Tube R2C69, SG24, High Frequency Probe

Figure 1 Profile of the defect in tube R2 C69 of steam generator 24 as measured with the high-frequency plus-point at 1000 kHz and 800 kHz.

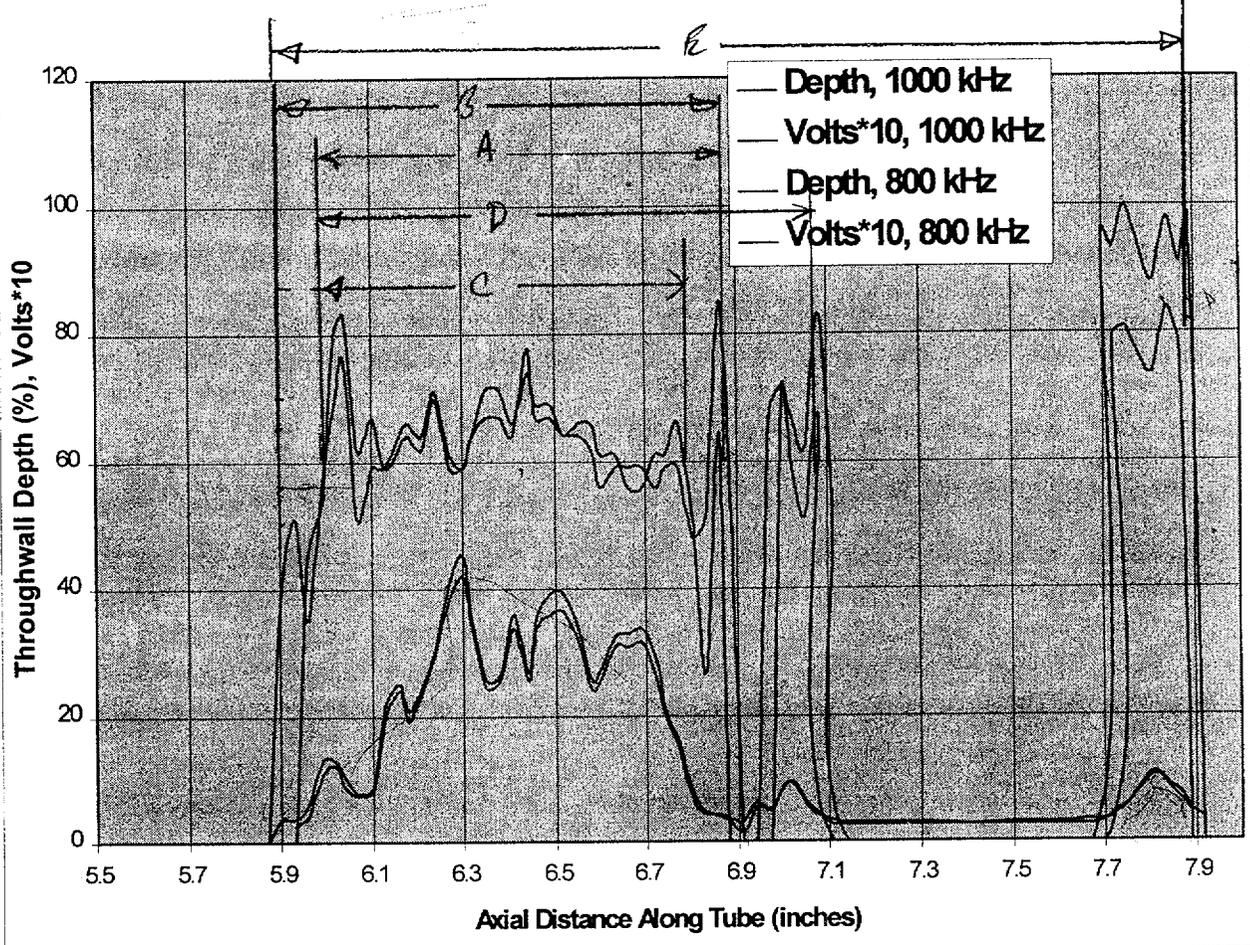
$d_A = 62\%$, $L_A = -1$, $P_A = 5171$ $d_D = 53\%$, $L_D = 1.1$, $P_D = 6943$
 $d_B = 58\%$, $L_B = 1.0$, $P_B = 6384$
 $d_E = 60\%$, $L_E = 1.0$, $P_E = 6139$ $d_C = 40\%$, $L_C = 2.0$, $P_C = 8372$

However, this tube had very little noise even with the old mini

plus-point probe. The indication located at about 7.8-inches has a maximum value slightly greater than a volt, and the agreement between the two frequencies is not as good in this region.

Tube R2C4 of SG24, High Frequency Probe

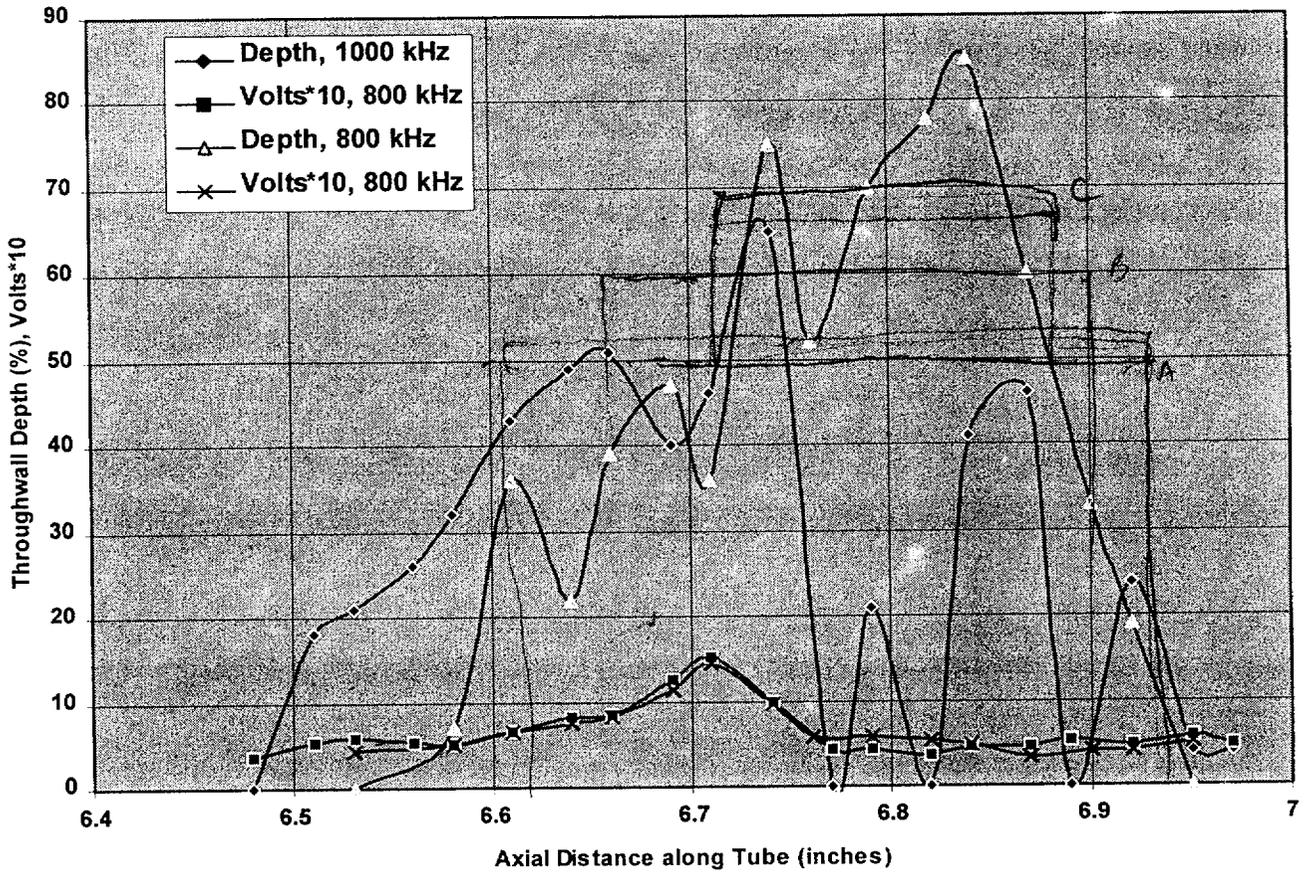
$d_p = 72\%$, $L_p = 0.075$, V_A ... experimental

Marginally detectable
i.e. low POD for this
type of flaw

$L_{TOT} = .23''$

Noise level?

Missed with mid-range probe

Tube R2C74, SG24, High Frequency Probe

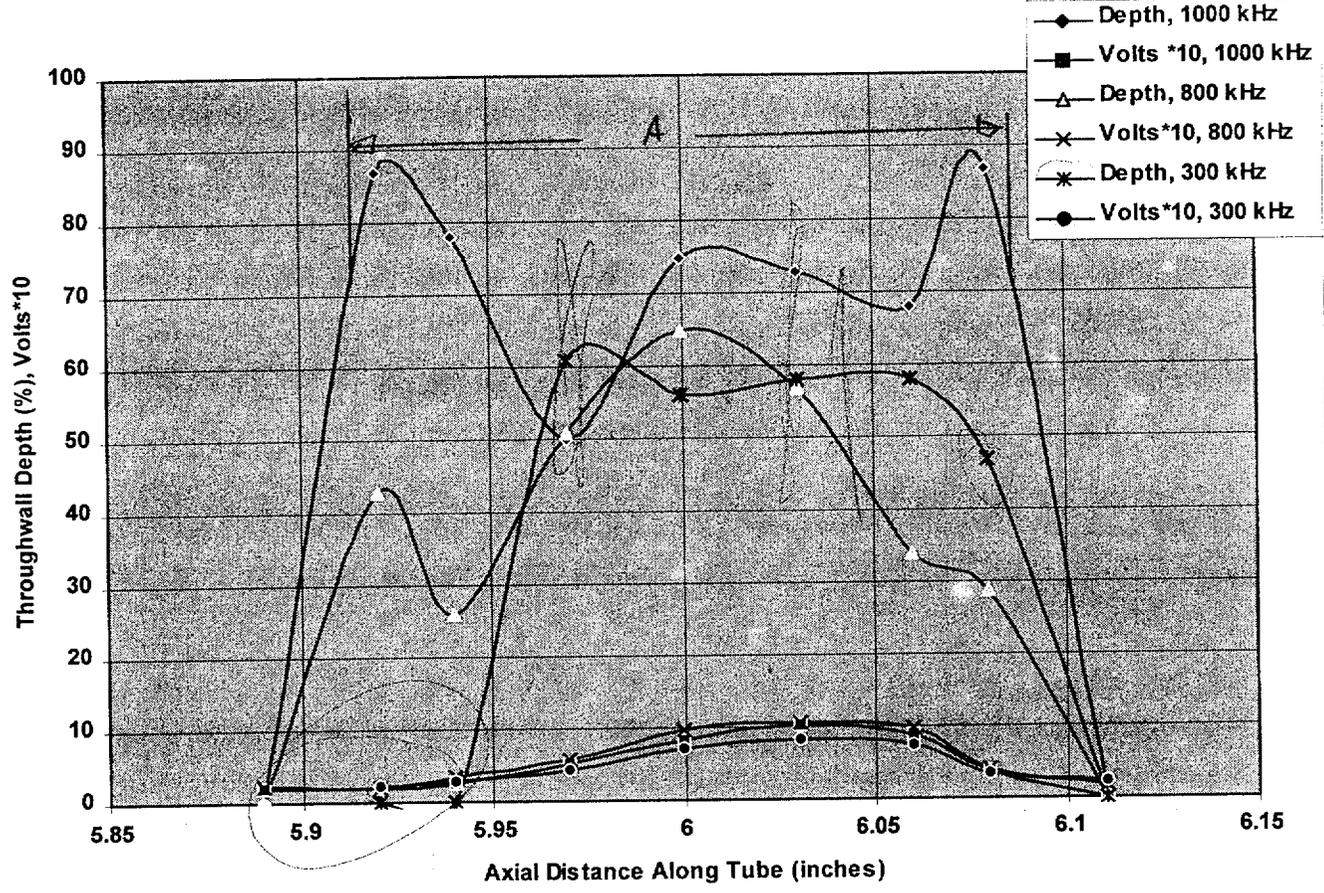
$$L_{TOT} = .42 - .45$$

$$L_A = .38, d_A = 52\%, P_A = 7597$$

$$L_B = .24, d_B = 60\%, P_B = 8058$$

$$L_C = .16, d_C = 70\%, P_C = 9495$$

Tube R2C71, SG24, High Frequency Probe

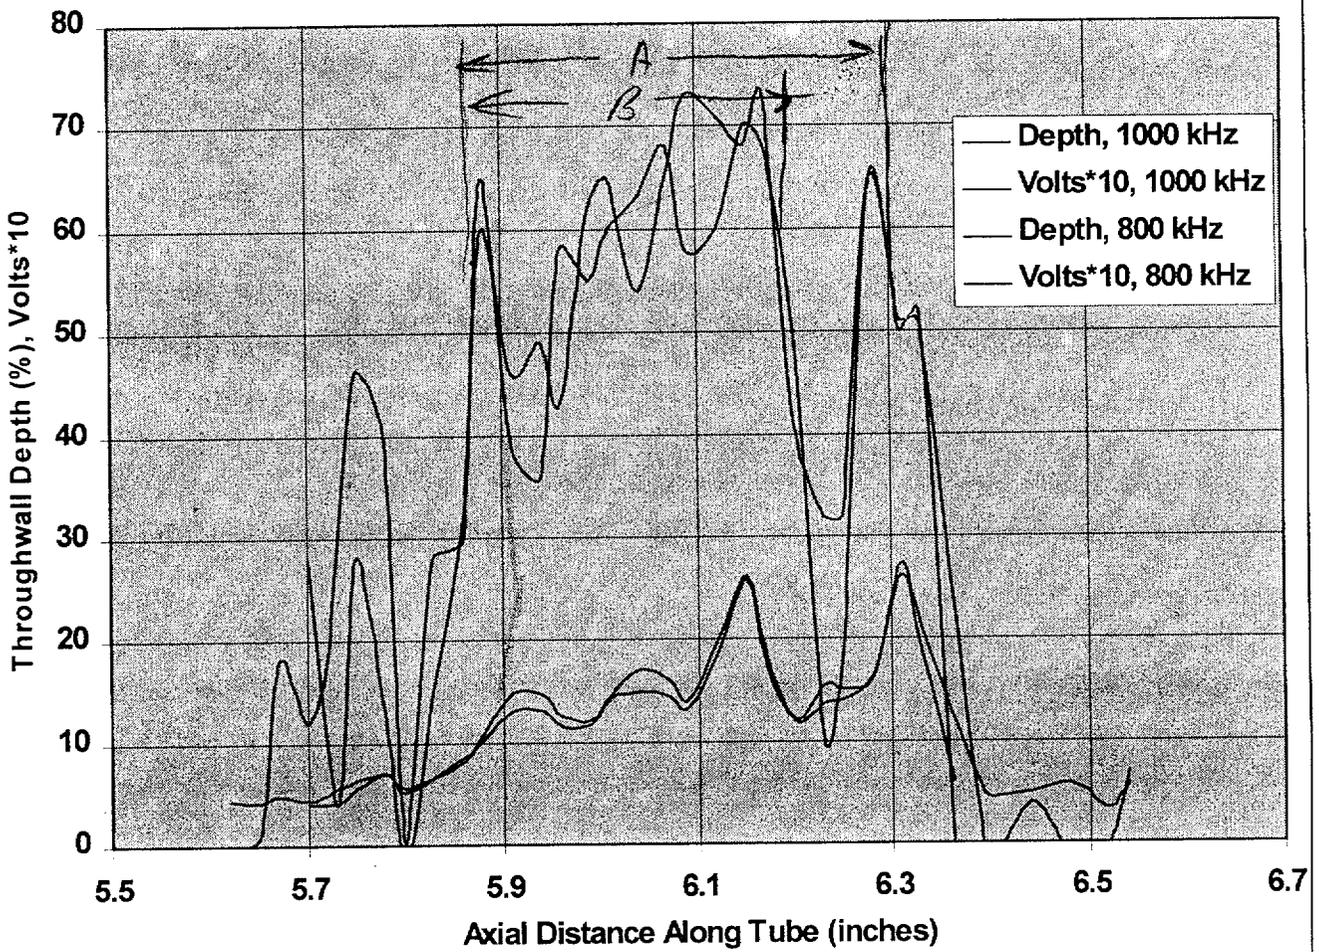
What was the noise level

Need 9927W
over all length
to explain leakage
at 1741 psi
Need 95% TW for
leakage at 2500

$L_A = .43, d_A = 55\%, P_A = 7059 \text{ psi}, \text{ no leakage at } 4500 \text{ psi}$

$L_B = .3, d_B = 60\%, P_B = 7120 \text{ psi}, \text{ no leakage}$

$L_C = .25, d_C = 65, P_C = 7892 \text{ psi}, \text{ no leak}$

$L_d = .10, d_d = 70, P_d = 10567, \text{ no leak}$
